# FINAL PLAT LOT 1, BLOCK 1 CROSSINGS ADDITION

SITE PLAN REVIEW

## RACETRAC SITE PLAN - SH 205 NORTH OF IH-30 AND LAKESIDE CHEVROLET

**Agenda Item:** P&Z 91-1-CUP/SP/FP - Hold Public Hearing and Consider Recommending Approval of a Request From Racetrac, Inc., for a Conditional use Permit for a Building Not Meeting Materials Requirements and Approval of a Site Plan and Final Plat for a Self Serve Gas Station Located on SH-205 North of I-30

3 FRONT ELEVATION  
A-2 1/4"=1'-0"

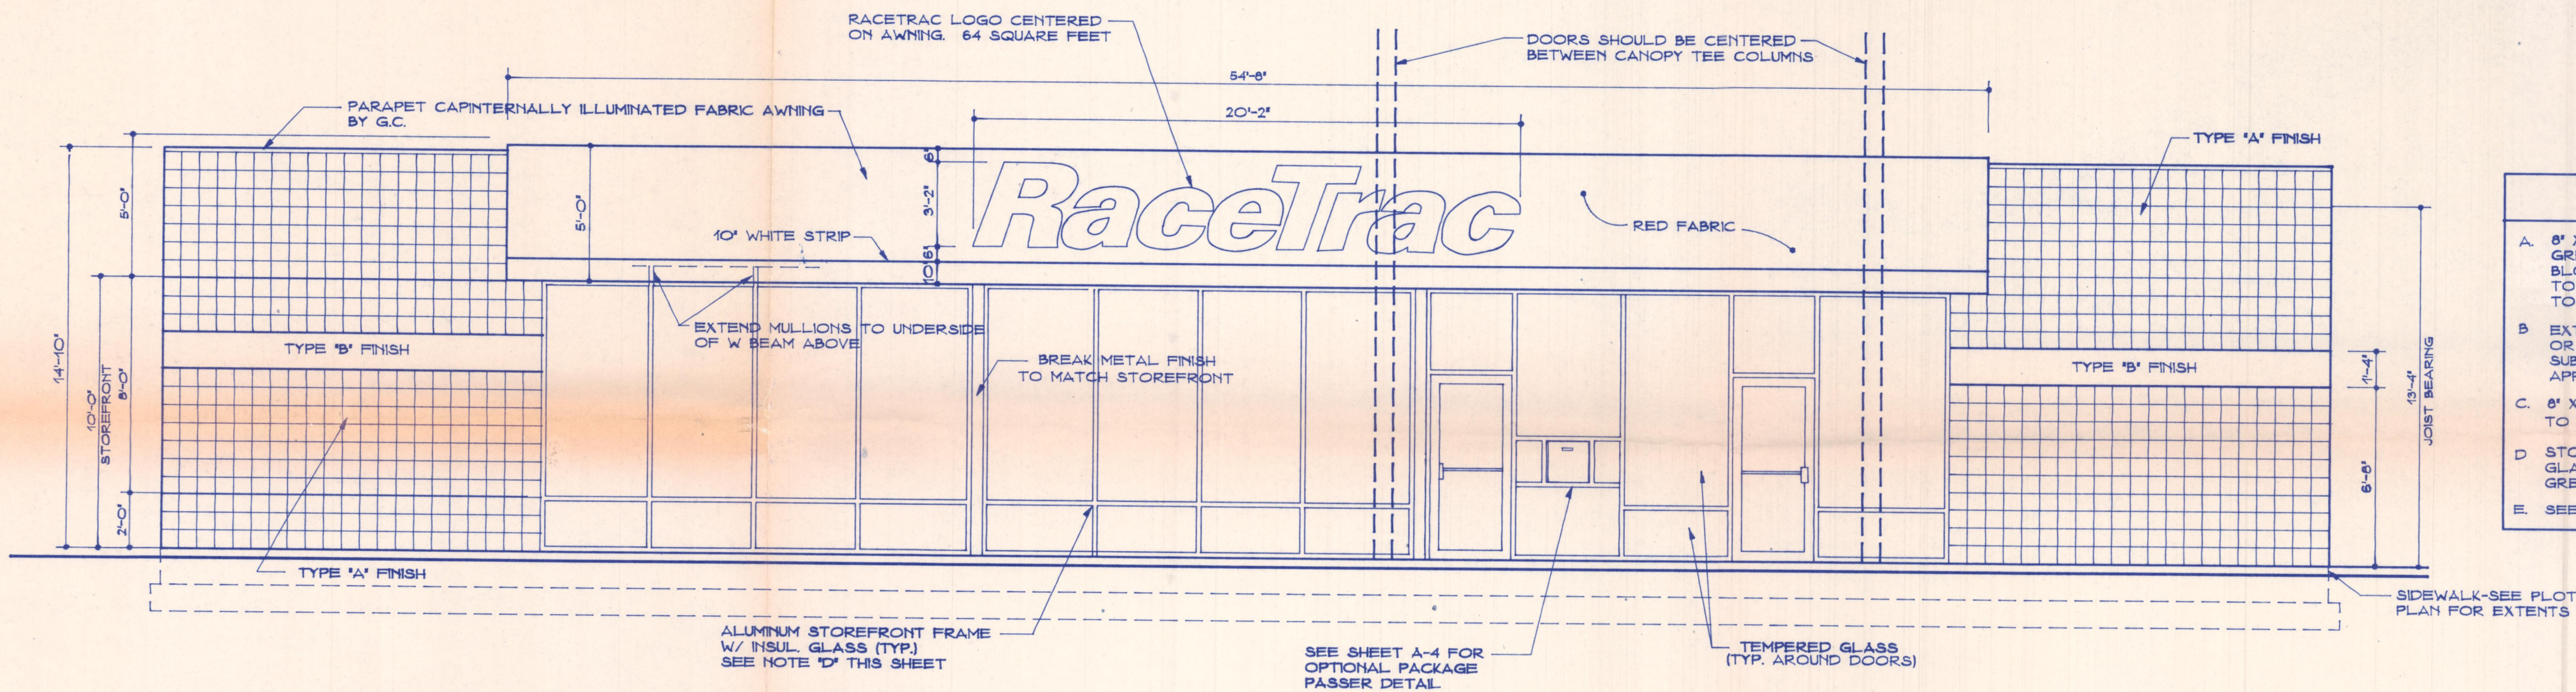
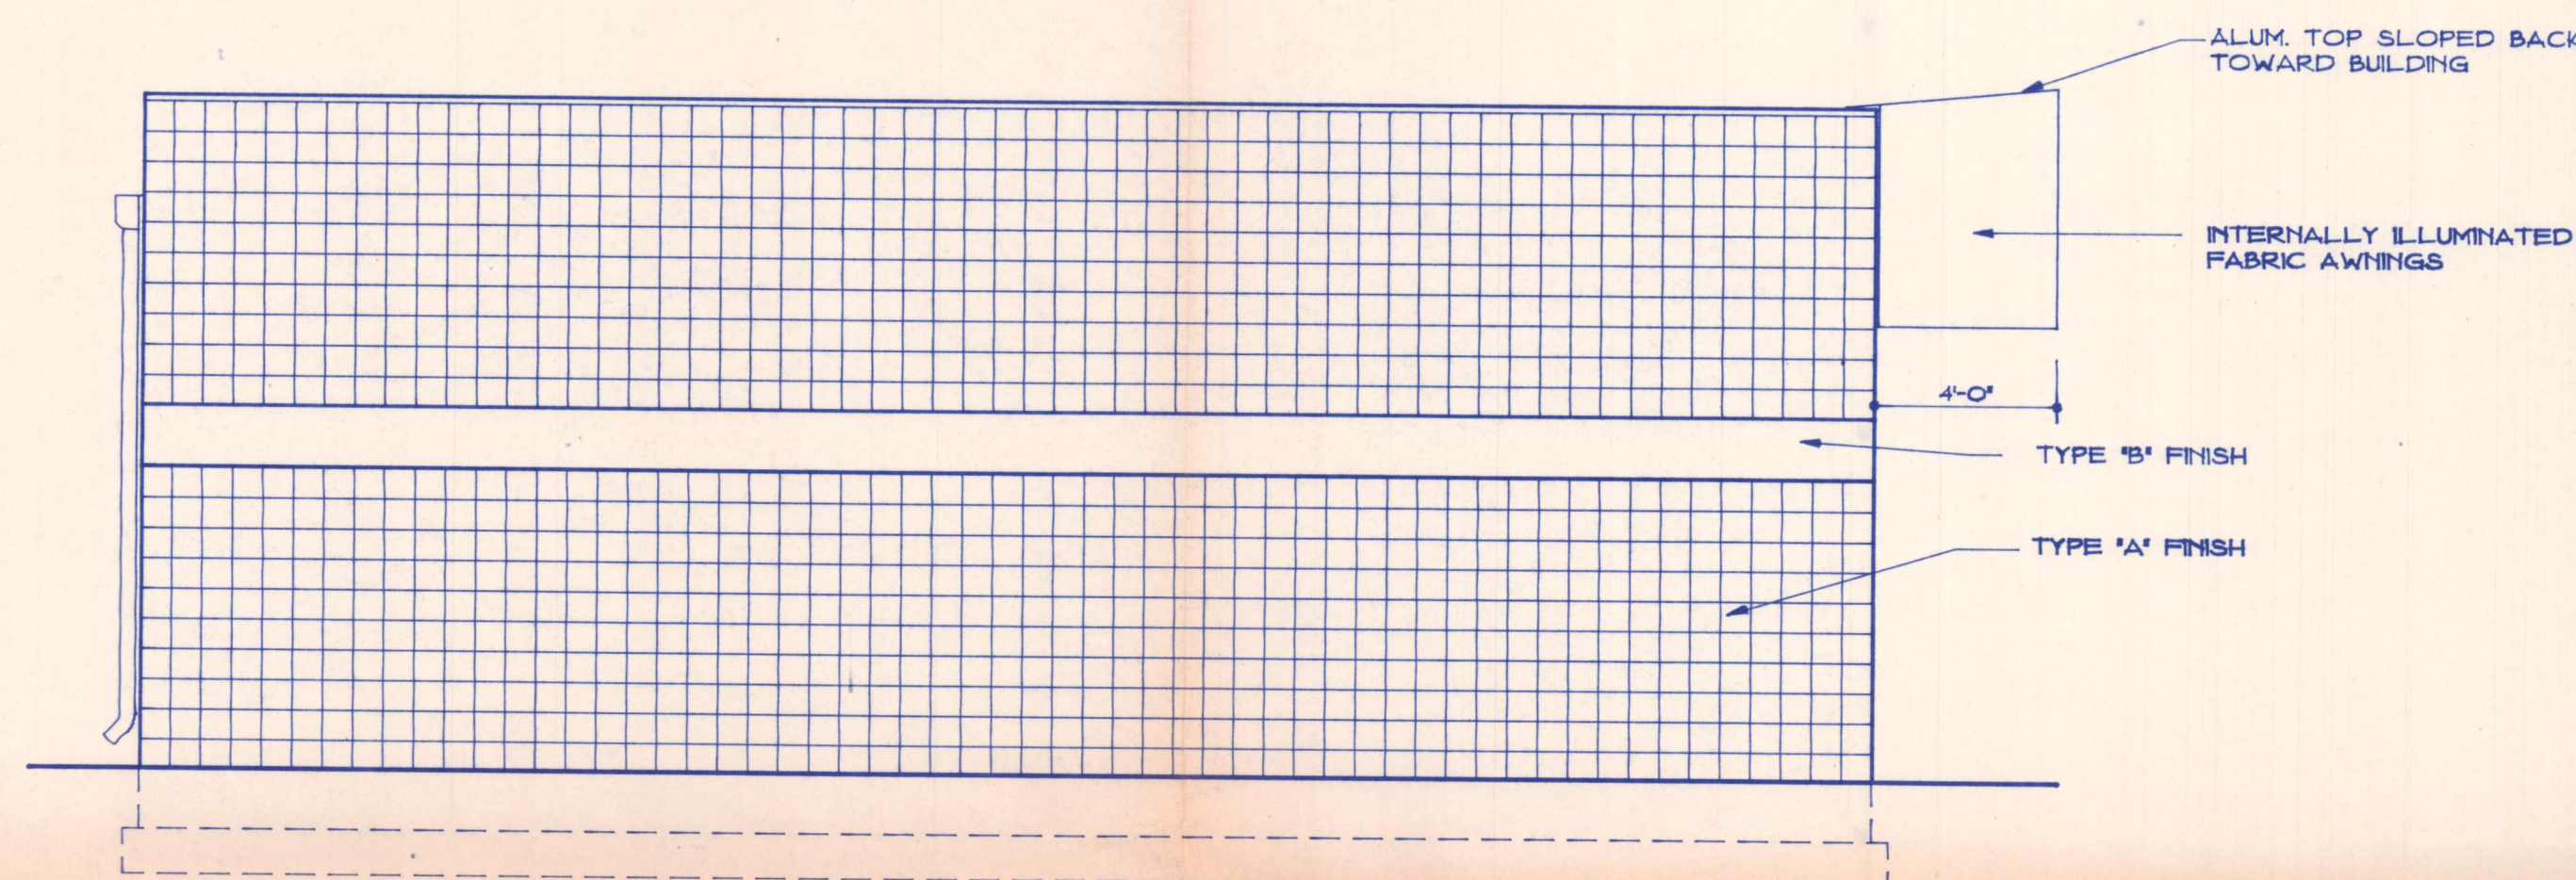
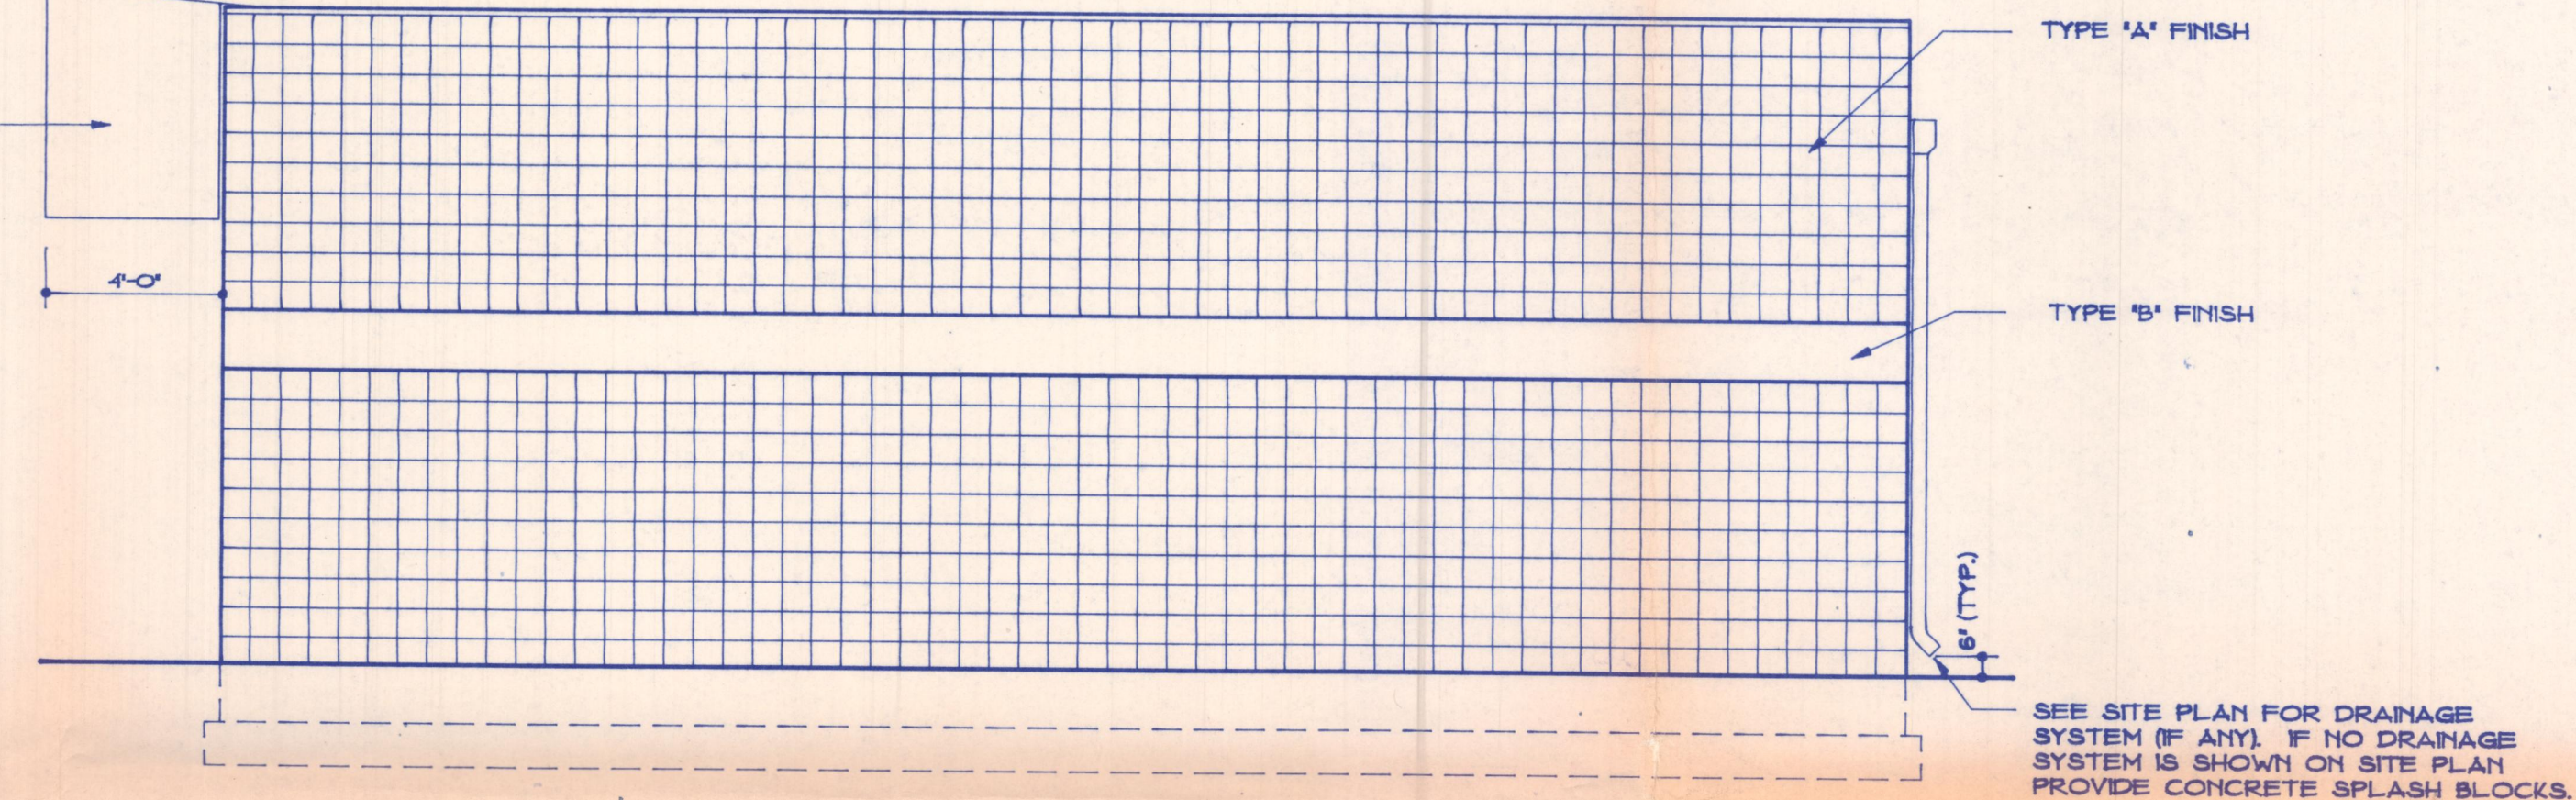
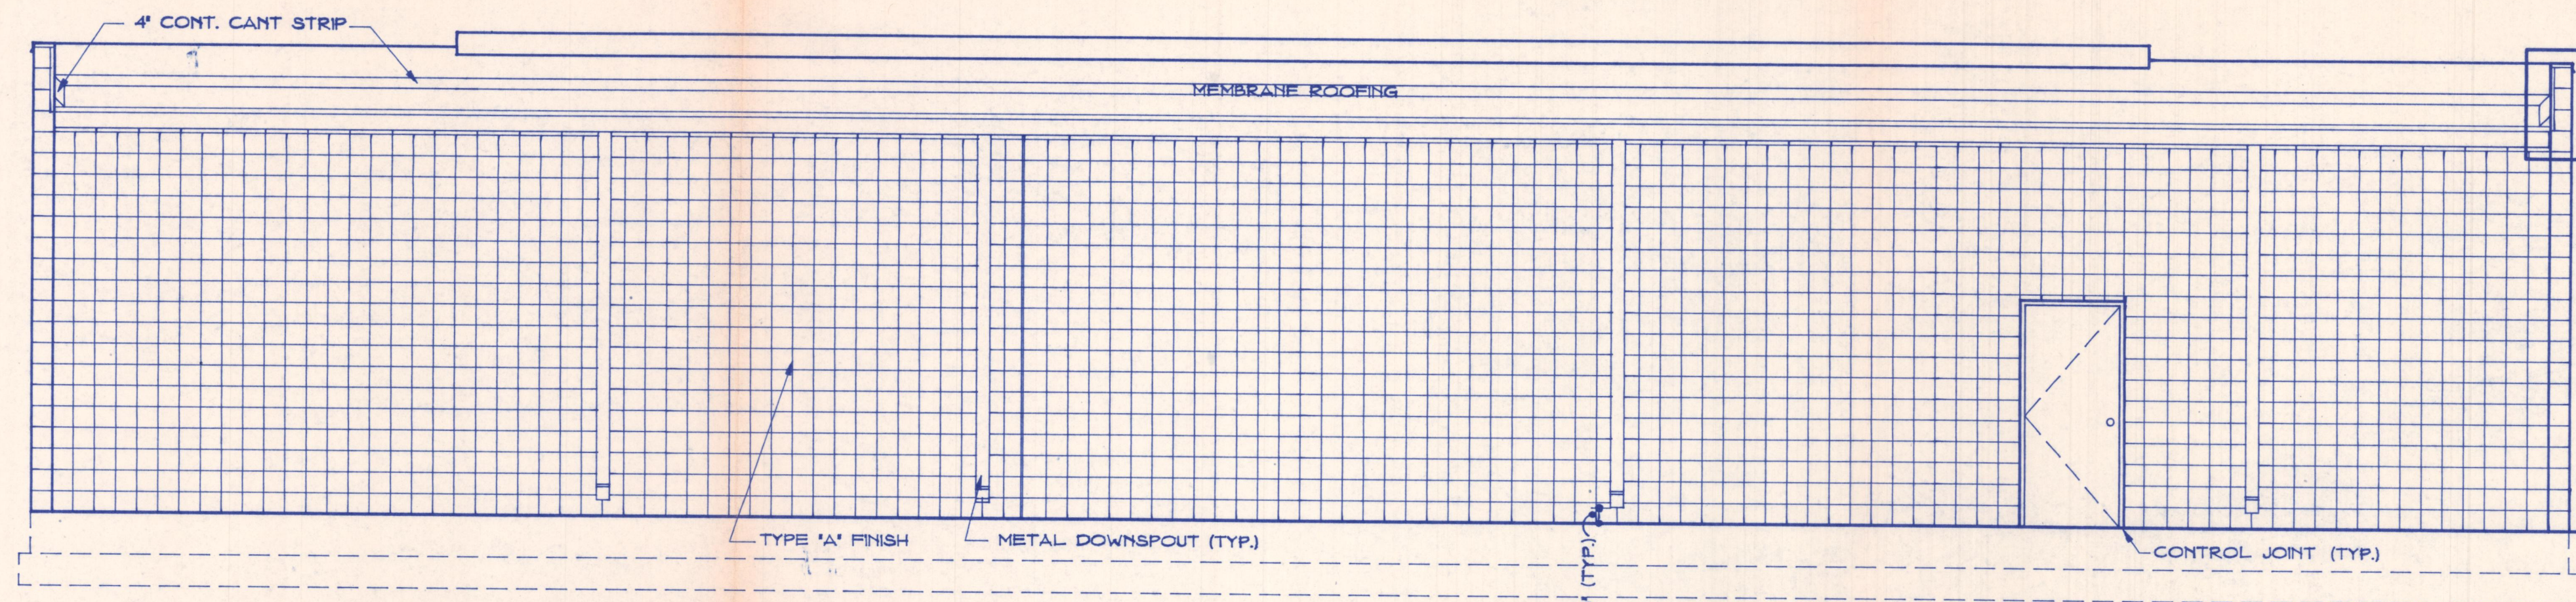
Building - the building is proposed to be constructed out of a concrete block material. This is very similar to the material used by Braum's for their building. This material does require a CUP to be used. They do not show a parapet wall along the back of the building but they are willing to put a wall along the rear. This should be included as a condition in the approval.

Canopy supports and sign support - They plan to use a stucco material to screen the metal supports for both the sign and canopy rather than brick. The stucco would be painted grey to match the building.

The Commission recommended approval of the site plan with the conditions that a parapet wall be constructed along the back of the building to match the other walls, and that the canopy supports and the sign pole be wrapped with the split face block to match the material used on the main structure.
